Access Compliance Report

Public Rights-of-Way

Intersection ID: 28773	Main Street: ROYAL_HIGHLANDS_CT	Cross Street: THATCHER_HALL_CT	Location: SW
ADA ID: E32F240E3496	Ramp Type: BlendTrans1	Initial Pass/Fail: Pass	Overall Compliance: No
Severity Score: 17.75			
Codes/Mitigation Info/Possible Solution		Field Measurements/Component Compliance

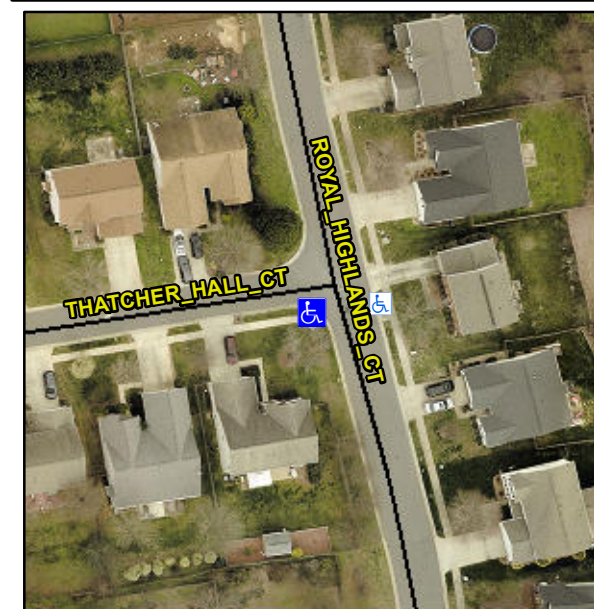
Not Found, R304.5.3, R305, R302.7.2

Compliance	Description	Data	Compliance	Description	Data
N/A	Ramp Length (in)	42.0	Yes	BlendTrans Slope (%)	3.4
Yes	Ramp Width (in)	51.0	No	BlendTrans XSlope (%)	4.4
N/A	Flare Type LT	Sloped	N/A	Flare Type RT	Sloped
N/A	Flare Slope LT (%)	9.2	N/A	Flare Slope RT (%)	1.5
N/A	Flare Traversable LT?	No	N/A	Flare Traversable RT?	No
Yes	Landing Length (in)	48.0	No	DWS Provided?	No
Yes	Landing Width (in)	51.0	N/A	DWS Contrast?	No
Yes	Landing Slope (%)	1.7	N/A	DWS Length (in)	N/A
No	Landing X Slope (%)	3.1	N/A	DWS Full Width?	No
N/A	Landing Curb? (Y/N)	No	N/A	DWS Offset (in)	N/A
N/A	Shared Landing?	No			
Yes	Gutter Ponding?	No	Yes	Gutter Slope (%)	2.5
No	Gutter Lip Ht (in)	0.3	No	Gutter X Slope (%)	4.2
N/A	Painted X Walk1?	No	N/A	Painted X Walk2?	N/A
	X Walk 1 Direction	To E		X Walk 2 Direction	N/A
	X Walk 1 Width (in)	N/A		X Walk 2 Width (in)	N/A
	X Walk 1 Slope (%)	2.9		X Walk 2 Slope (%)	N/A
	X Walk 1 X Slope (%)	0.9		X Walk 2 X Slope (%)	N/A

N/A	Ramp inside XWalk1?	N/A	N/A	Ramp inside XWalk2?	N/A
	Road Slope (%)	0.9		Clear Space?	Yes
	Road X Slope (%)	2.9	N/A	Clear Space to XWalk (in)	N/A
Yes	Any Obstructions?	No	Yes	Storm Grate/Utility Hazard?	No
	Obstruction Type			Storm Grate/Utility Type	
		N/A			N/A
			Yes	Surface Condition? (G/P)	Good
			No	Curb Slope (%)	5.1

Remove & Replace Curb Ramp With Two New Directional Ramps or Equivalent. Remove & Replace Gutter.
